DESIGN REVIEW BOARD
THURSDAY, NOVEMBER 5, 2015 6:30 PM

**DESIGN REVIEW BOARD
THURSDAY, OCTOBER 1, 2015 6:30 PM**

**City of Reynoldsburg
Design Review Board
STAFF REPORT
November 5, 2015**

OLD CONNELL HARDWARE STORE

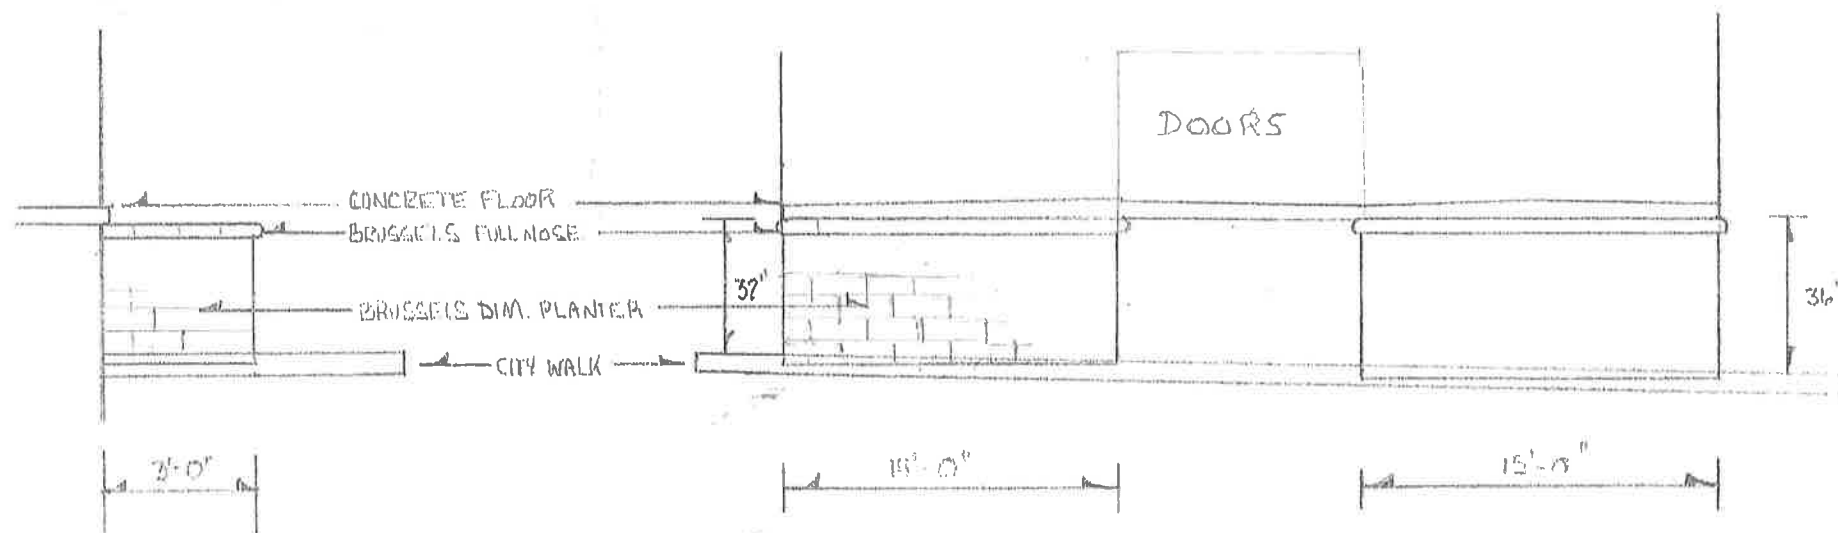
Staff has reviewed historic photographs of this building and found that masonry style planters were present on the site until 2009. The proposed planters are slightly smaller than the historic ones.

The historic planters were brick, and the applicant is proposing to utilize a similar brick to construct the proposed planters. Staff is comfortable with the proposed brick color because it complements the stone watertable utilized for the first 2'-3' of the facade above grade.

South elevation

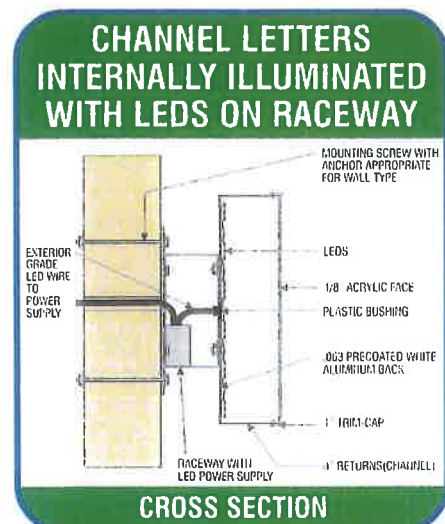
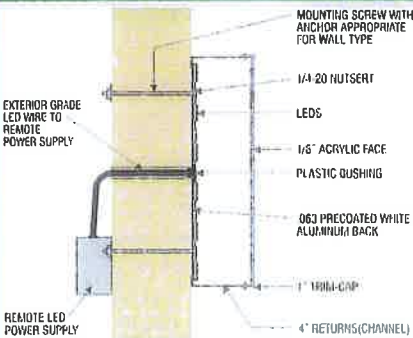
The applicant has proposed to replace the existing wall signs with two new wall signs labeled Sign #017 and Sign #020 on the applicant's plans. The structure is on a corner lot, the applicant is permitted one wall sign on the facade parallel to each frontage. Sign #017 is an internally illuminated channel letter sign mounted on a raceway. The sign is 42.10sf and contains two colors, when not including the raceway. Sign #020 is a 100.62sf internally illuminated channel letter sign mounted directly to the building's fascia. A 50sf wall sign is the maximum permitted by Code on this wall, but Staff believes that applicant may have used a different calculation method for the sign area. Per Code, Reynoldsburg utilizes a method commonly known as the smallest contiguous area. Staff recommends that the applicant recalculate the sign area and submit that information on plans for a zoning sign permit application.

1. That the applicant provide revised plans recalculating the area of the sign #020 or reduce the area of the sign to meet the Code.
